**ATTACHMENT 3**

Re: Beaverbrook Heritage Home, Vaughan  
Load Review Report

Photo 3- Basement Level

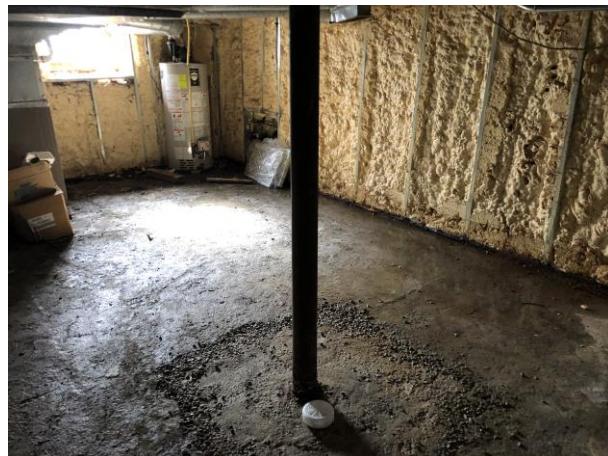
- The basement floor was observed to be a concrete slab on grade. Refer to photo 3.
- It was observed at the basement that the existing floor structure above was exposed to view. Refer to photo 4.

- It was observed on site that at the basement, the existing floor joist above were typically 2"x10" wood joists spaced at 16" on centre, supported by a centre 10"x10" wood beam. There was also observed a timber posts and several steel posts, and it appeared that concrete footings were previously installed below grade (as per the change in concrete surface immediately around the steel posts). Refer to photos 3-5.

Based on the above information, it is our opinion that the base building ground floor structure requires reinforcement for the proposed office usage. The existing floor joists where not sistered are undersized for the proposed live loads or are currently showing signs of wood creep and excessive deflection. We recommend that all the existing floor joists and stair beams be sistered. We also recommend that the existing wooden post is to be replaced by a new steel posts, and the existing damaged steel post bases be removed and repaired. New concrete footings are to be poured atop the existing

slab on grade to give standoff from the standing water, with all new and existing steel coated with a zinc rich paint primer system to protect from further moisture damage.
